Groundwater Transfer Review Summary Form

Transfer/PA # T- 14637

Ground Water Review Form:

Application: T-14607

**Application T-14637 Bernert
T4S R1E Section 4**

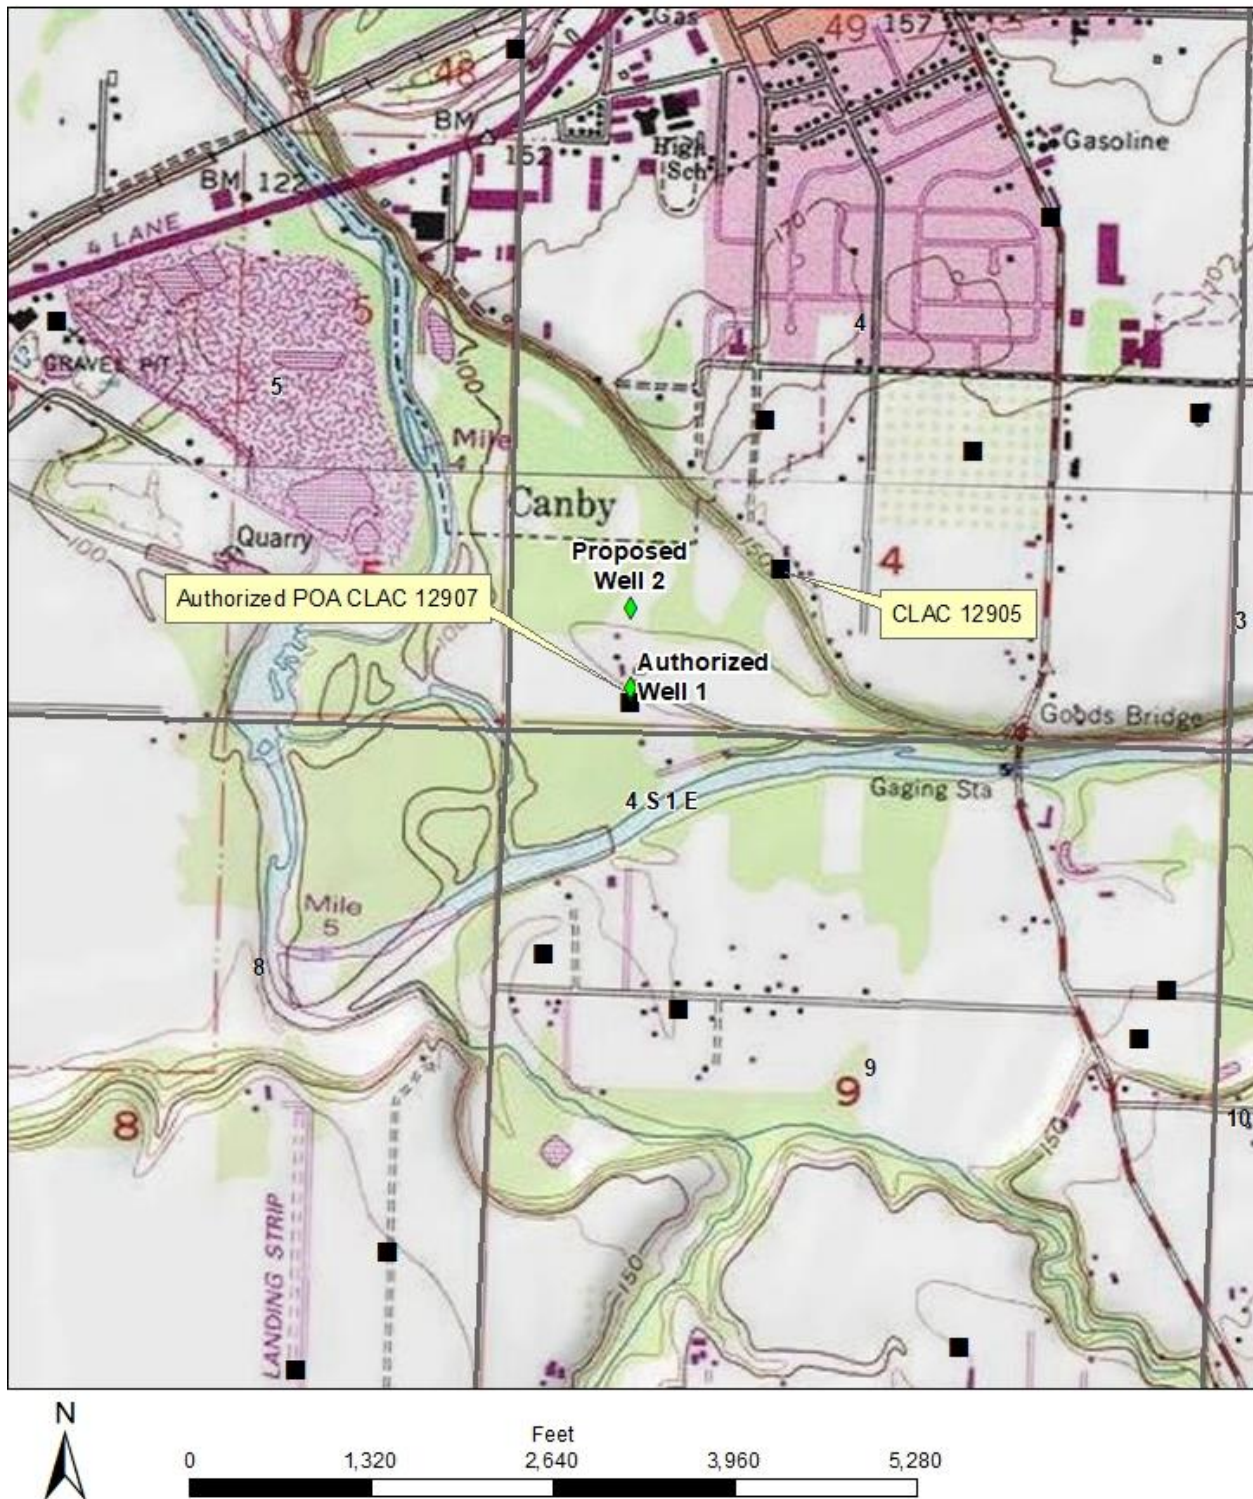
1. Will the proposed POA develop the same aquifer (source) as the existing authorized POA?
☒ Yes ☐ No Comments: The authorized POA CLAC 12907 is a 48-inch diameter, 10-foot deep dug well approximately 900 feet north of the Molalla River. The proposed POA Well 2 would be constructed with a 12-inch diameter casing to a total depth of 25 feet below ground surface. Both wells produce water from shallow alluvial deposits of the Willamette aquifer within the Canby alluvial fan (Gannett and Caldwell, 1998).

4. a) Will this proposed change, at its maximum allowed rate of use, likely result in an increase in interference with **another ground water right**?
☒ Yes ☐ No Comments: Authorized POA CLAC 12907 is located approximately 1,400 feet from CLAC 12905, an authorized POA for Certificate 34107. The proposed POA Well 2 would be located 1,100 feet from CLAC 12905. The reduced intervening distance proposed by this change would likely result in an increase in interference with CLAC 12905.

- b) If yes, would this proposed change, at its maximum allowed rate of use, likely result in another groundwater right not receiving the water to which it is legally entitled?
☐ Yes ☒ No If yes, explain: Because of the unconfined and highly transmissive nature of the aquifer tapped by the subject wells, the proposed change is unlikely to cause CLAC 12905 or similarly located wells to not receive the water to which they are legally entitled.

5. a) Will this proposed change, at its maximum allowed rate of use, likely result in an increase in interference with **another surface water source**?
☐ Yes ☒ No Comments: The proposed POA Well 2 is ~1,350 feet north of the Molalla River, whereas the authorized POA Well 1 (CLAC 12907) is ~840 feet north of the Molalla River. The increased intervening distance is not likely to result in increased interference with the Molalla River.
